1. No Meeting Agenda

1.1. Old Business

# 78 Wauwinet LLC

78 Wauwinet Road  
Nantucket, MA 02554

1 South Elevation (Washington Street Side)  
Scale: 1/4"=1'-0"

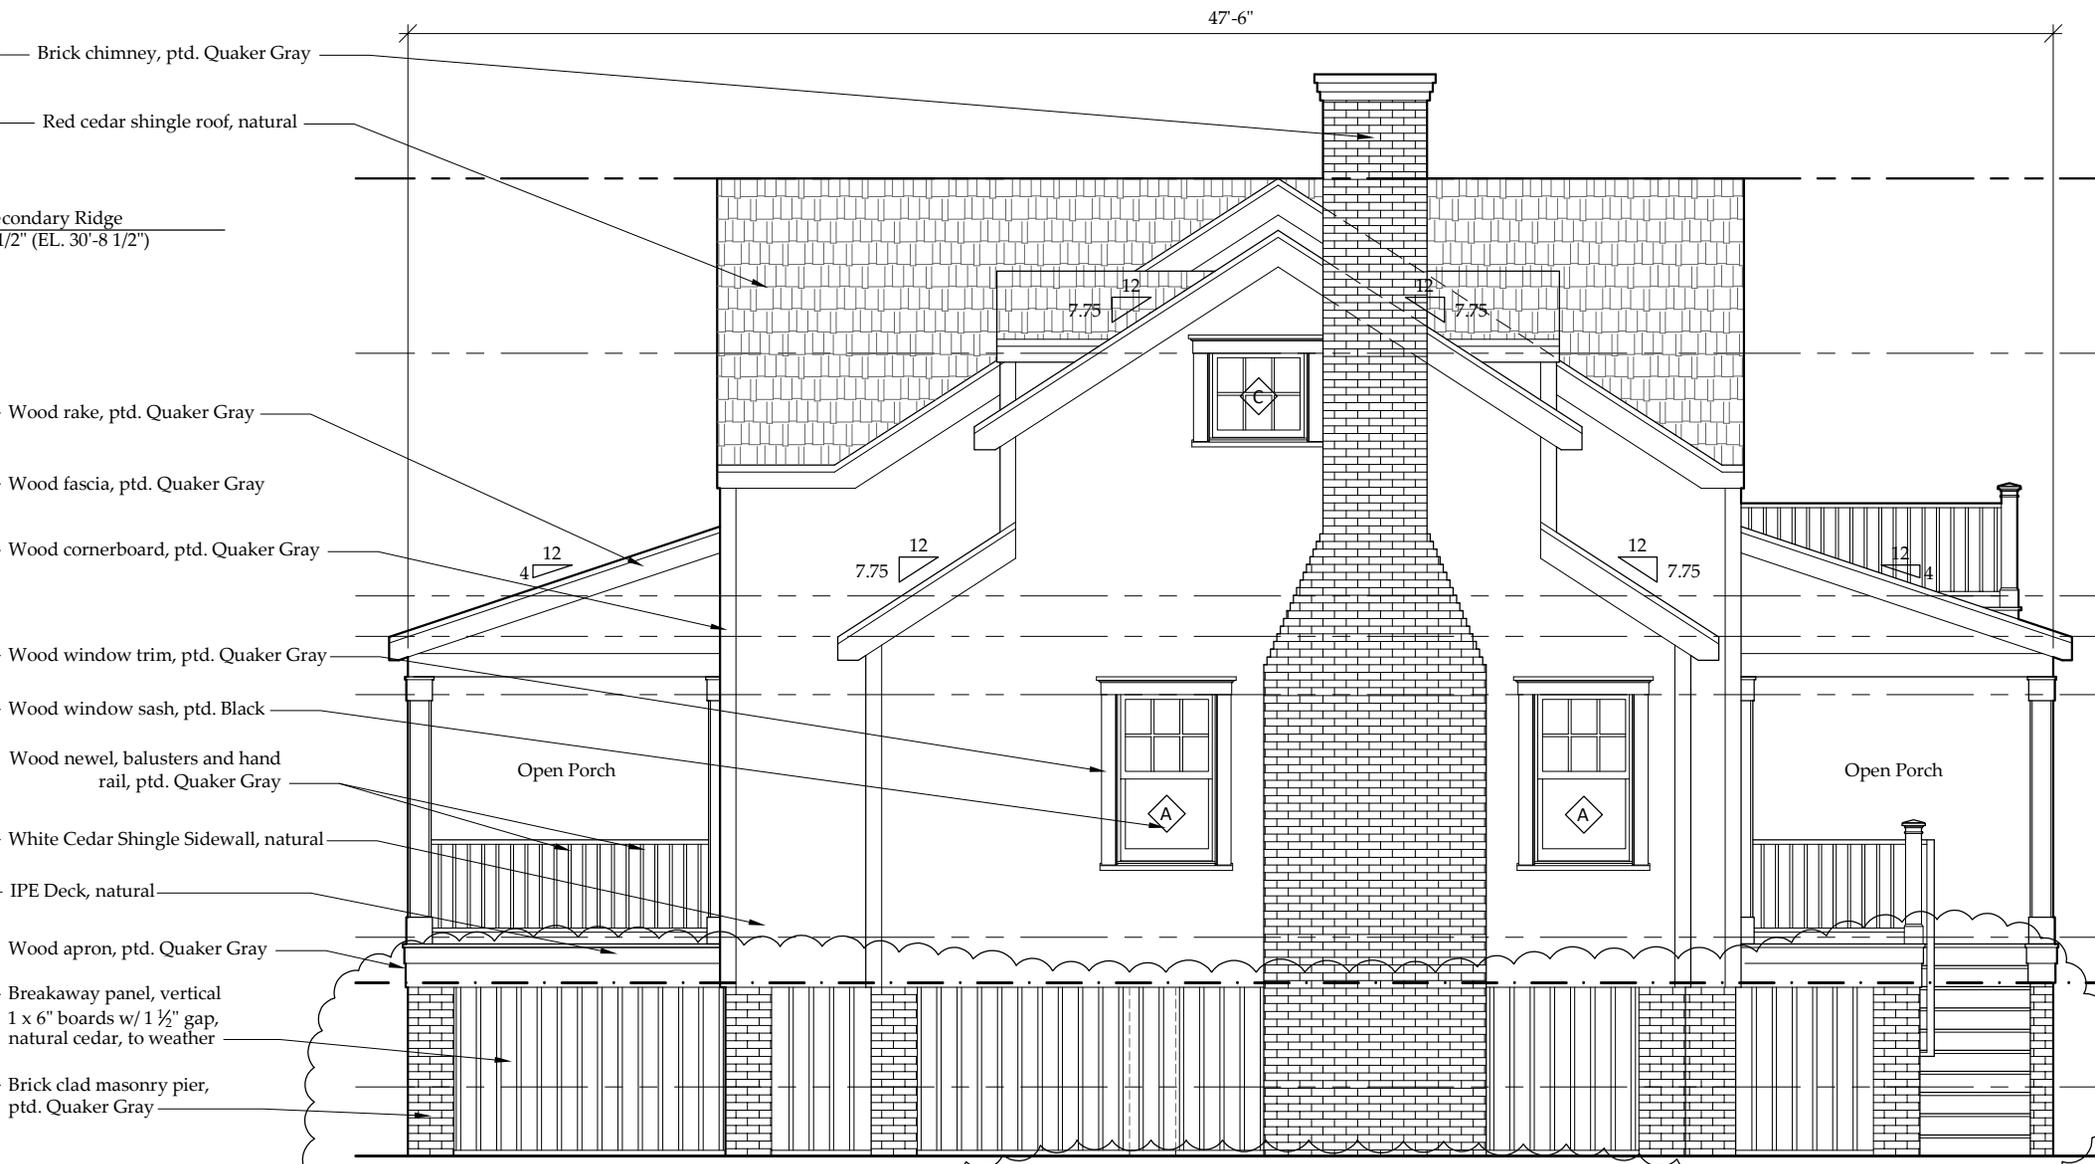
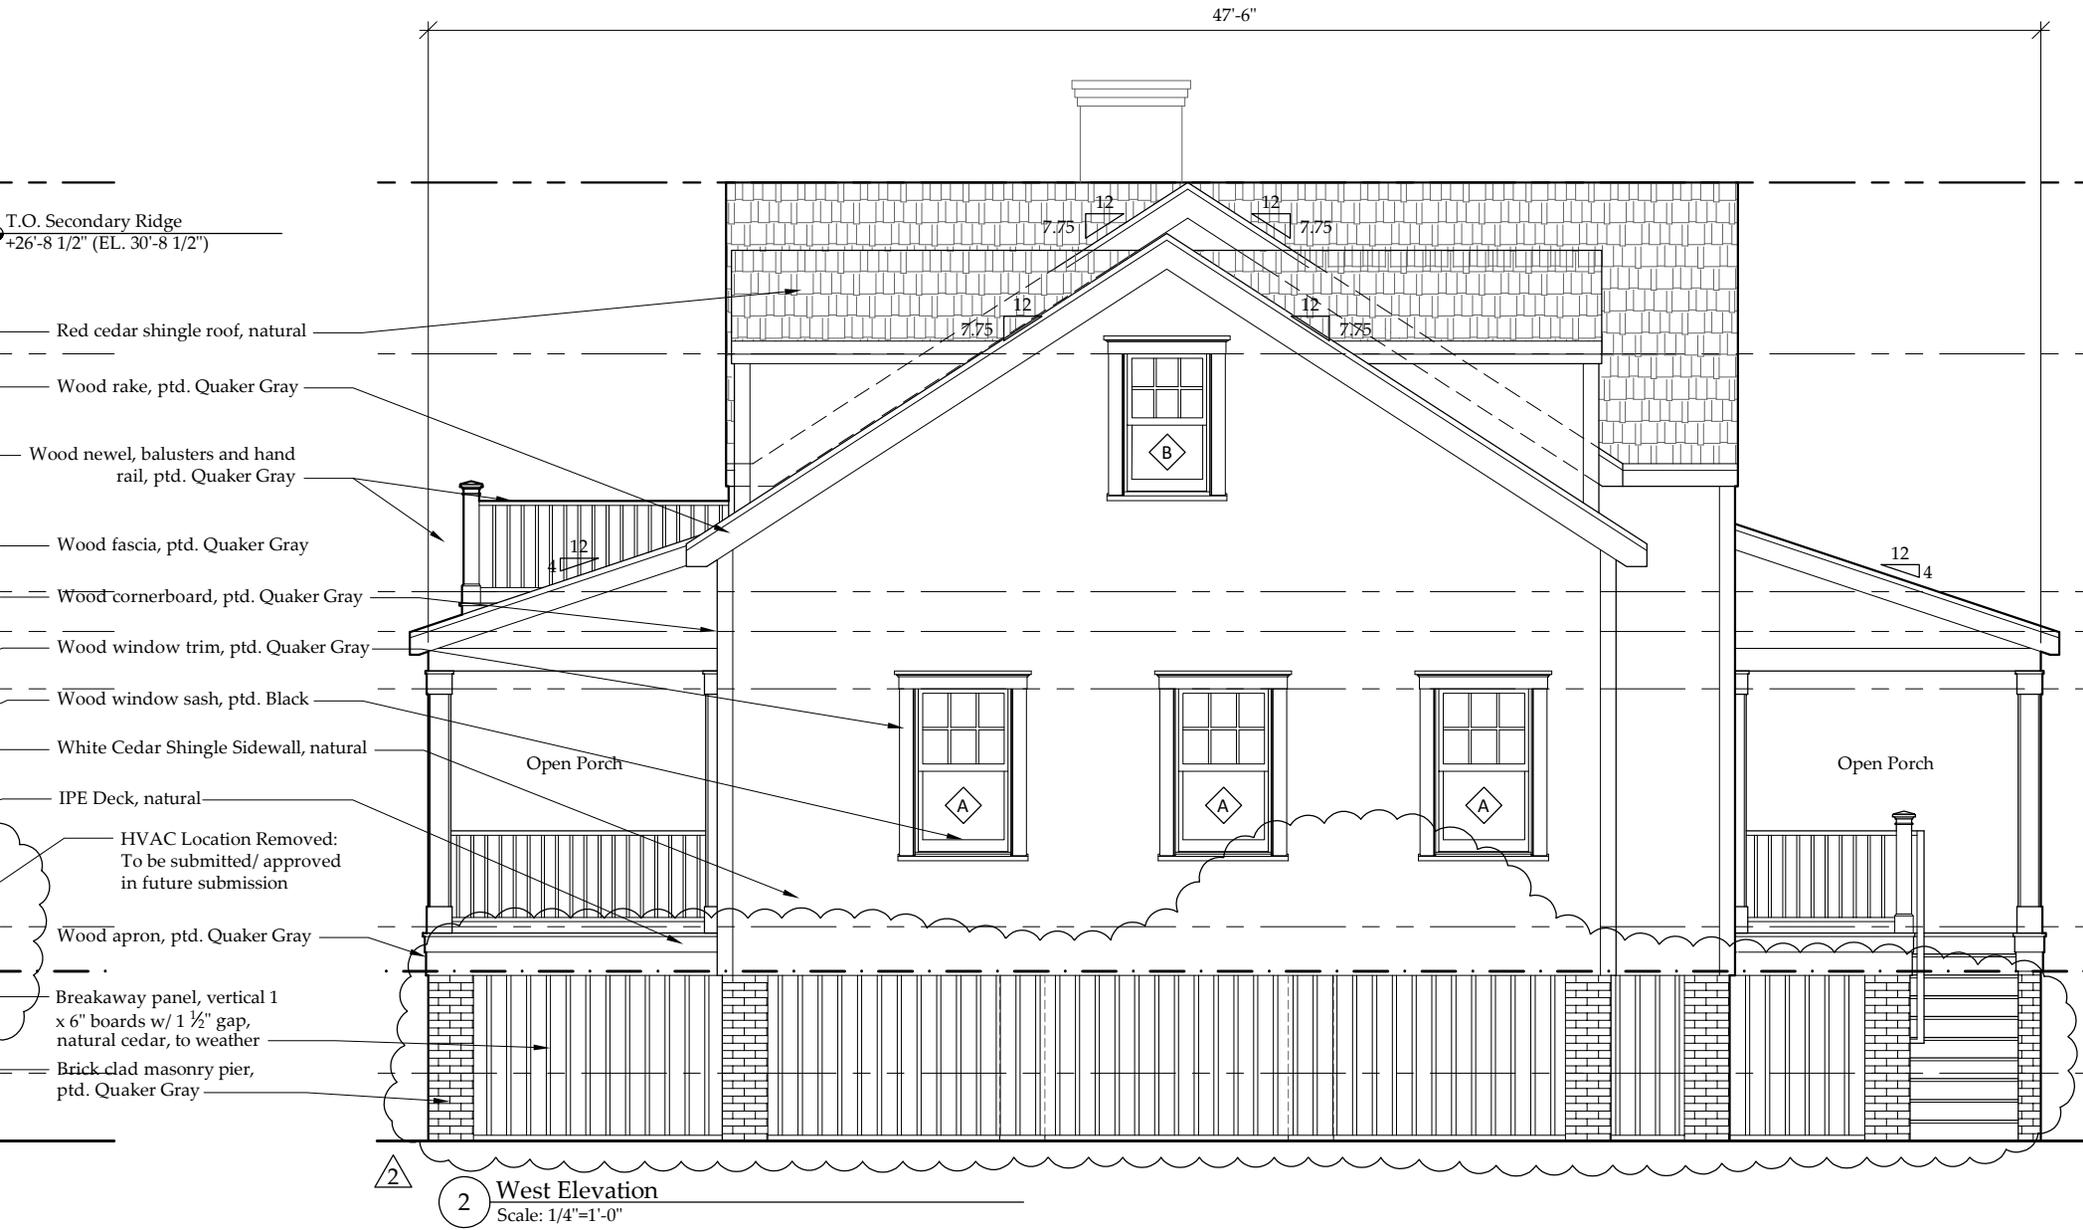
6.	Great State Prop. 02-0589	92 Washington Street	New dwelling	42.2.3-22	Smith-Hutton Arch
Voting	Coombs, Oliver, Welch, Watterson				
Recused	None				
Documentation	Architectural elevation plans, site plan, photos, correspondence, and advisory comments.				
Representing	No name given.				
Public	None				
Concerns (5:24)	<b>Coombs</b> – Read HSAB (no quorum) comments. <b>Owner Rep.</b> – Reviewed changes made per previous concerns; have a surveyor letter confirming the 9-foot minimum lift relative to the FEMA flood level. The garage is simulated-divided lights (SDL). <b>Watterson</b> – Okay with all the changes. Asked what others think about the skirting, should it be on the outside. It's half-way defensible; this is 65 feet from the road behind the garage and wood windows. <b>Welch</b> – If this were natural brick it should be painted. The skirting should be separated; it's detailed and too formal. The A/C should come back as a separate application. This is really high. Agrees about the north elevation fenestration. Asked for a description of the Norwood line of SDL windows; there should be consistency of the windows on all visible facades; he'd like to see a cut-sheet on these windows. <b>Oliver</b> – She's not sure what to think about the foundation skirting. Agrees with what's been said. Preferred the north elevation as it was previously approved; the pane pattern draws attention to it. The windows are SDL; in the old historic district (OHD) the visible facades should be true divided light (TDL). <b>Coombs</b> – This an important location in the OHD; the small buildings that were there have been demolished and what's going in doesn't look anything like what it was. The height should come down; it should be as small and simple as possible. The windows have to be TDL in the OHD.

Motion	<b>Motion to Hold for revisions and a tear sheet for the windows and the A/C removed from the application. (Welch)</b>				
Vote	Carried		Certificate #
